POST EXHIBITION - NEIGHBOURHOOD PLAN FOR "IOWNA" PRECINCT, MARSHALL MOUNT ROAD, MARSHALL MOUNT

The draft Neighbourhood Plan was exhibited from 28 February to 30 March 2022. As a result of the exhibition process, Council received four submissions. Subsequent discussion and revisions have occurred to finalise the Neighbourhood Plan. This report considers the revised post exhibition Neighbourhood Plan for the Iowna precinct and recommends that it be adopted by Council with amendments.

- 1 Location
- 2 Draft Neighbourhood Plan as exhibited
- 3 Revised Neighbourhood Plan for adoption
- 4 Additional Development Controls for inclusion in the amended Chapter D16 - West Dapto Urban Release Area

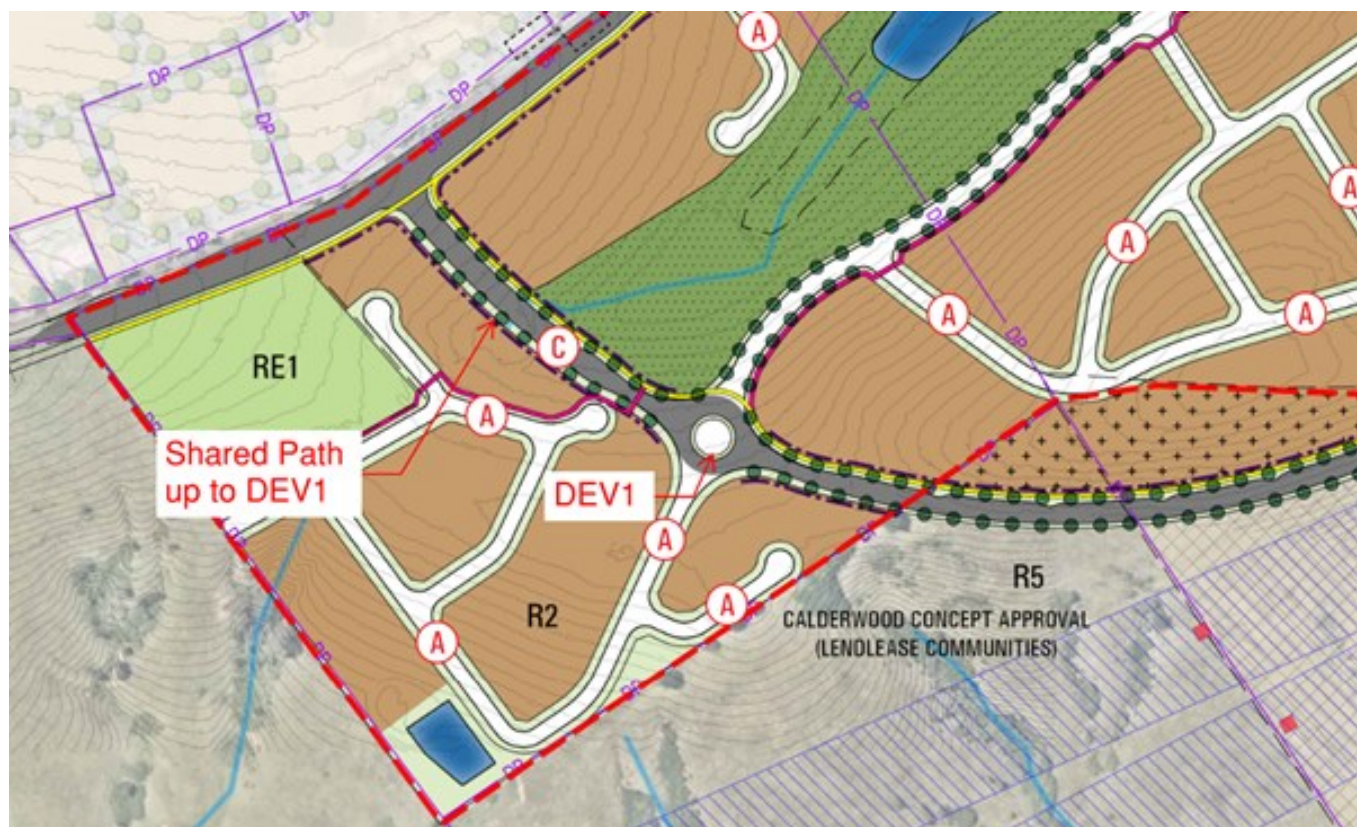
The Neighbourhood Plan has been amended to align with design work undertaken by Council for road widening of Marshall Mount Road and the proposed Marshall Mount Town Centre Bypass, including the intersection locations.

- Revision to reflect Council's 80% concept design, including -
 - Proposed location and levels of relevant roads.
 - Development intersection 6 location shift further south [see image below].

- Development intersection 4 treatment change to remove connection into lowna.
 - The section of bypass road between Marshall Mount Road and Development intersection 1 has a shared path along the southern side of the road as well [see image below].
